Figure 2.1-2 Reactor Core Safety Limit.

TABLE 3.2-1

DNB MARGIN

Figure 2.2-1 Trip Setpoint for Flux -- Δ Flux/Flow

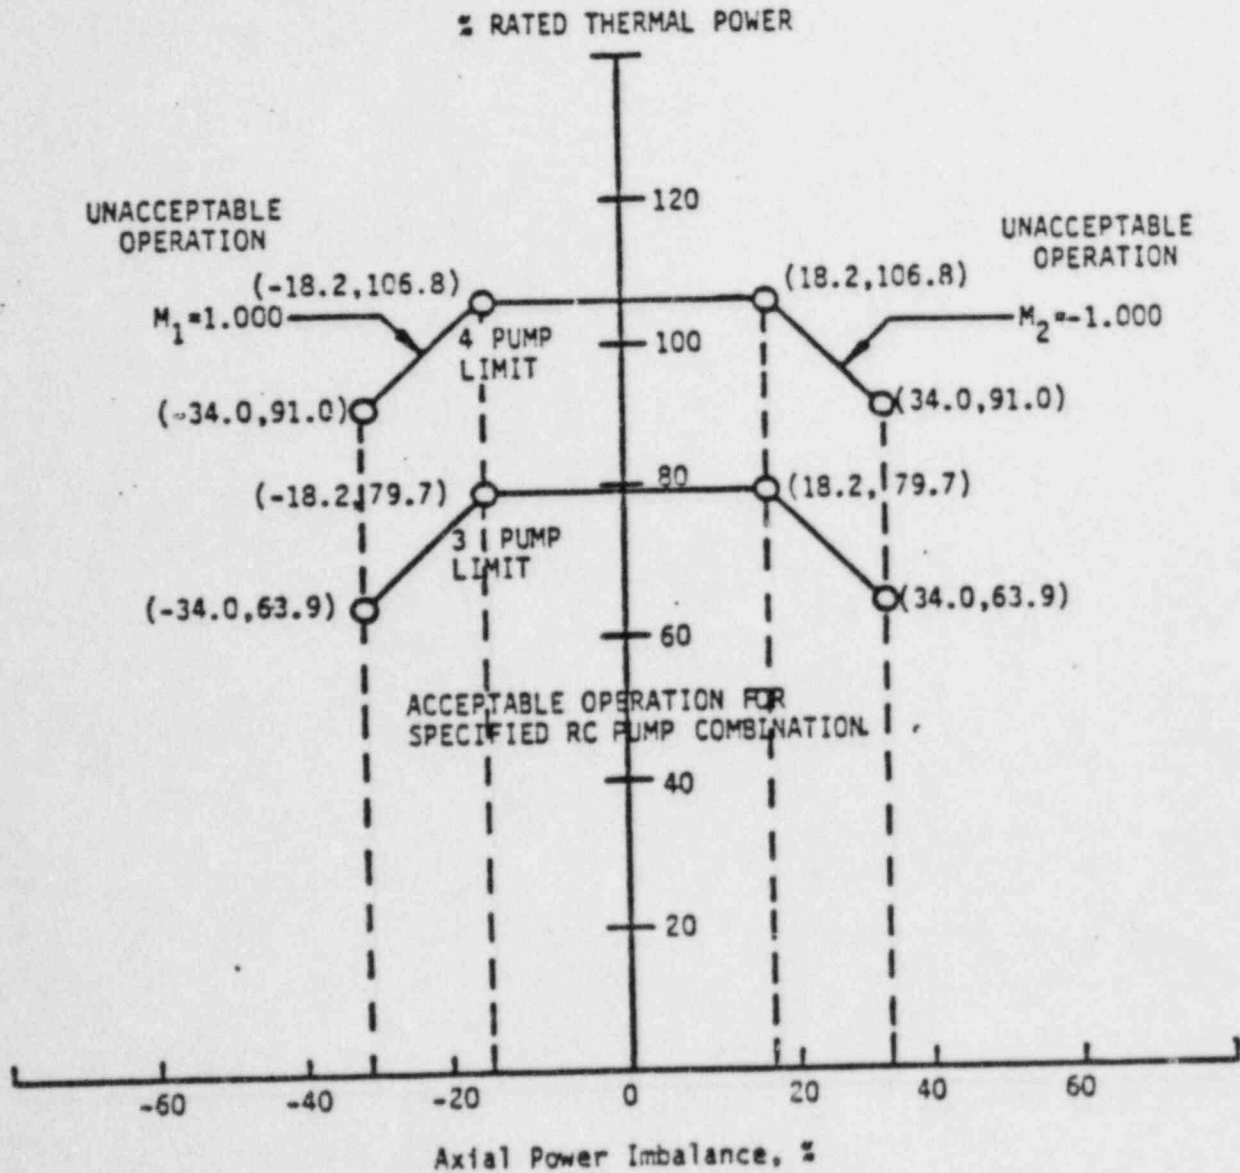
283,340

an approximately 25%

Curve shows trip setpoint for ~~25%~~ flow reduction for three pump operation (290,100 gpm). The actual setpoint will be directly proportional to the actual flow with three pumps.

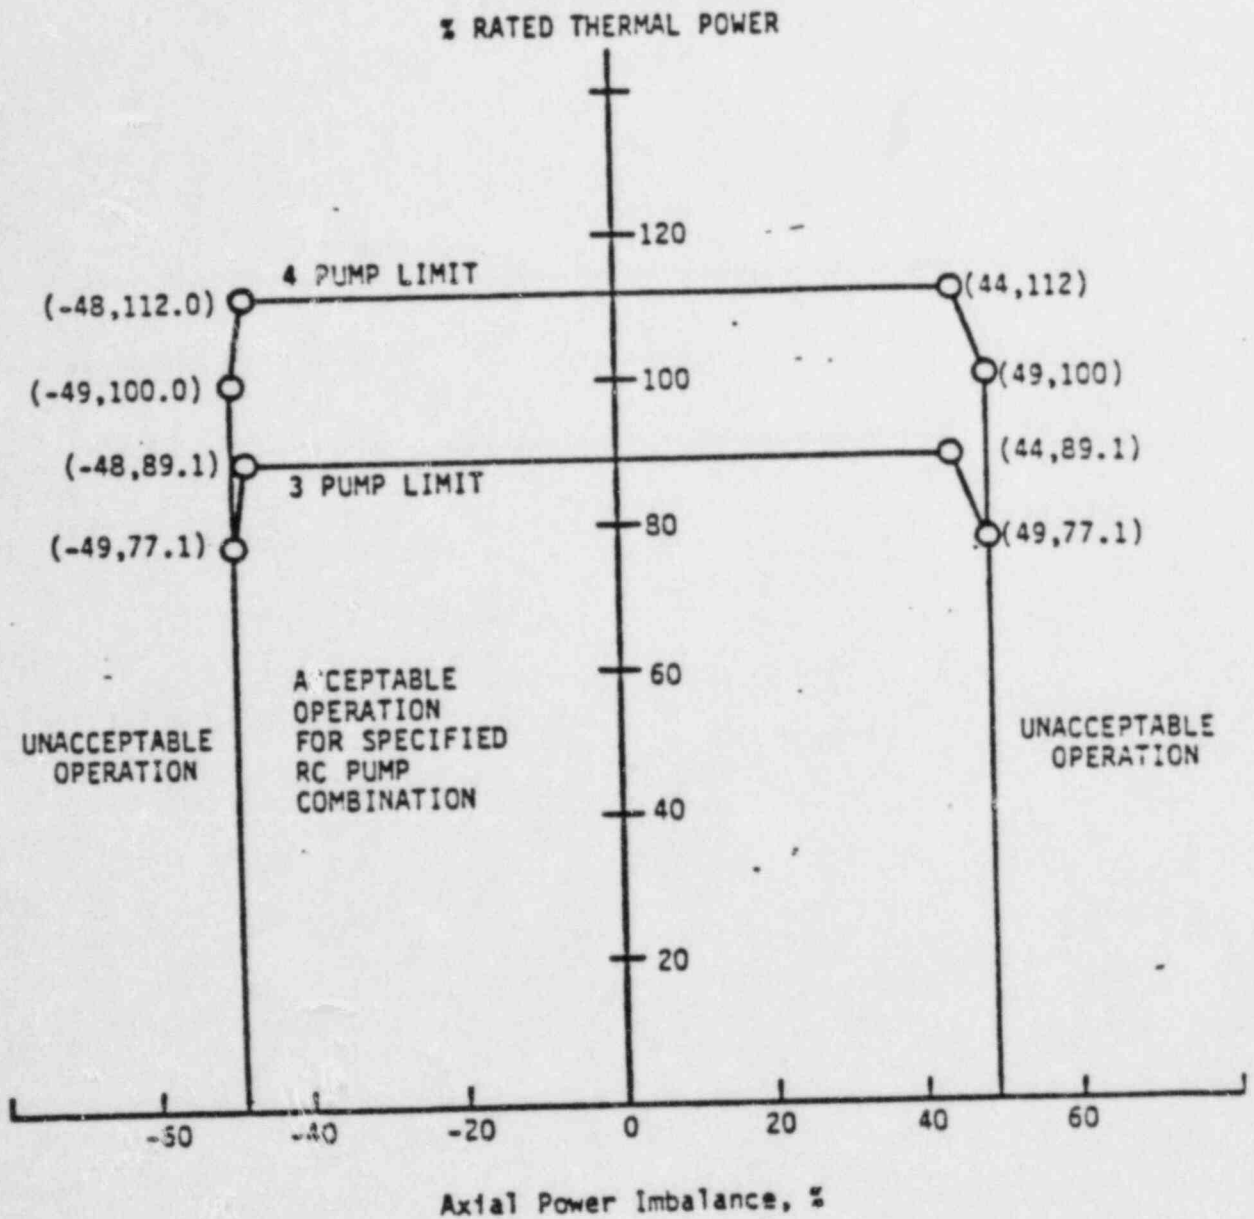
PUMPS OPERATING	REACTOR COOLANT FLOW, GPM
4	380,160 → 387,200
3	283,380 → 290,100

Basic Figure 2.1 Pressure/Temperature Limits at Maximum Allowable Power for Minimum DNBR

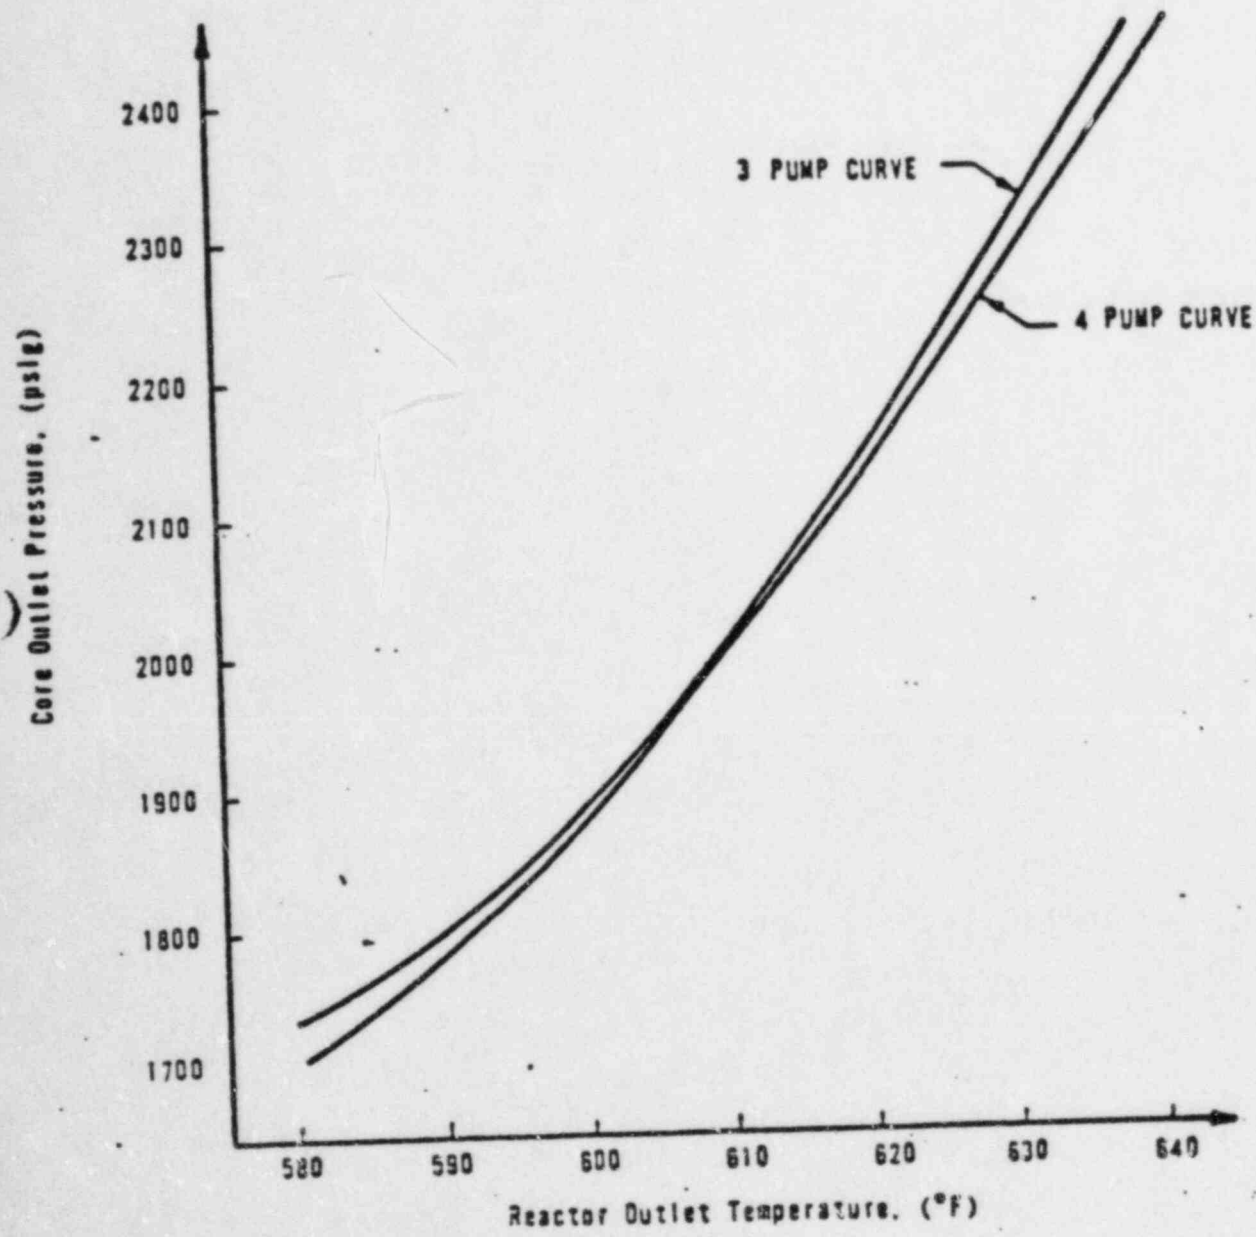
PUMPS	FLOW (GPM)	POWER
4	307,200	1125
3	290,100	80.3%

- 380,160 (circled) with an arrow pointing to the '4' pump row.
- 283,980 (circled) with an arrow pointing to the '3' pump row.
- 89.1% (circled) with an arrow pointing to the '80.3%' power value.
